UNITED STATES PATENT AND TRADEMARK OFFICE

Office Action Summary	Application No. 10/554,316	Applicant(s) CARMAN ET AL.	
	Examiner DNYANESH KASTURE	Art Unit 3746

DETAILED ACTION

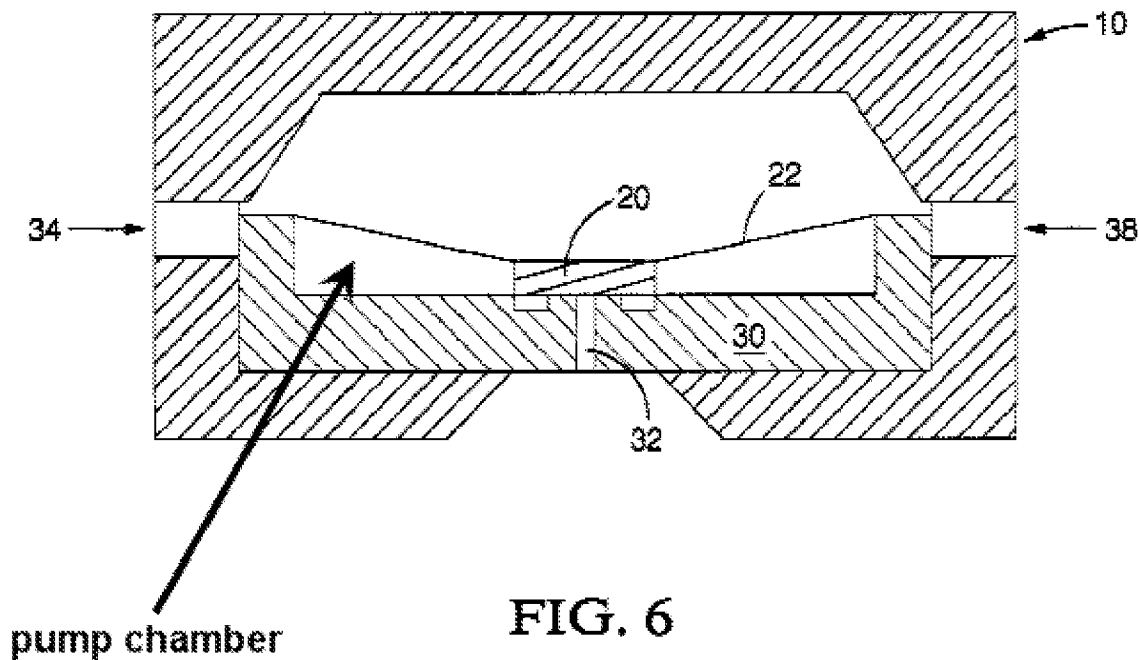
9. In Re claims 1 and 14, with reference to Figure 6 depicted above, Knebel et al discloses an actuation mechanism (title) comprising:

- an actuator body (10) comprising an actuation chamber (interior space) having a membrane seat surface (30)
- a membrane (22) comprising a shape memory alloy (SMA) that has a martensite-austenite transition temperature (Column 1, Lines 20-32: “..when the alloy is heated above a temperature threshold, the transition temperature, its crystal structure changes to austenite and the alloy returns to its original configuration..”)

- said membrane being located over said membrane seat surface as depicted to define a pump chamber between said membrane seat surface and said membrane.
Note that the inlet (34) has a higher diameter than the orifice (32) therefore the velocity of fluid exiting is higher than at entry since the volumetric rate is maintained for an incompressible fluid (fuel), therefore the fluid is “pumped” to a higher velocity.

- at least one inlet (34, 38) through which fluid is introduced into the pump chamber
- at least one outlet (32) through which fluid is removed from said pump chamber, said outlet being located at a spaced location from the inlet (outlet is in the center and inlet is at the periphery)

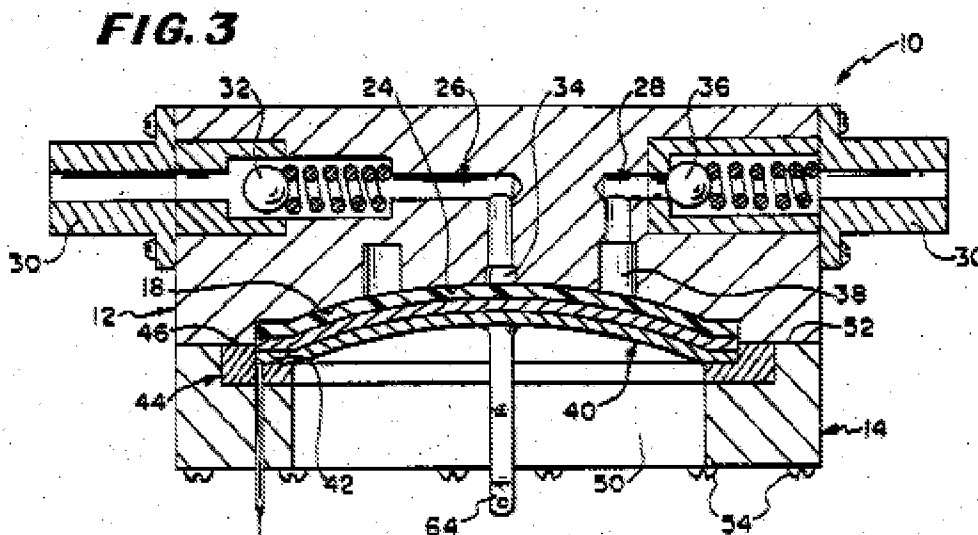
19. In Re claims 1 and 14, with reference to Figure 3 depicted above, Brown discloses an actuator body (10) with an actuator chamber (50) and pump chamber between deformable diaphragm/membrane (40) and seat (18), the diaphragm/membrane (40) comprising a bi-metallic element (58) and gasket (60), inlet

(34), bias pressure applicator (32), outlet (38) and heating elements (Column 5, Lines 35-38).

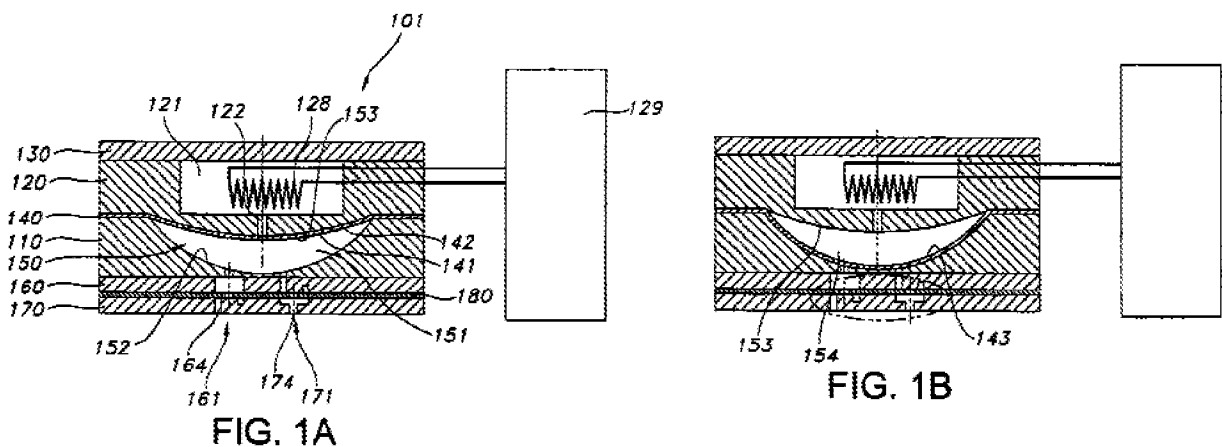
34. Nevertheless with reference to Figures 1A and 1B depicted above, Hansen discloses a dome shaped protrusion (153) extending into the pump chamber (formed between surface (143) of the membrane and the dome, the pump chamber is a part of the actuation chamber). The dome shape is a seat for the membrane.
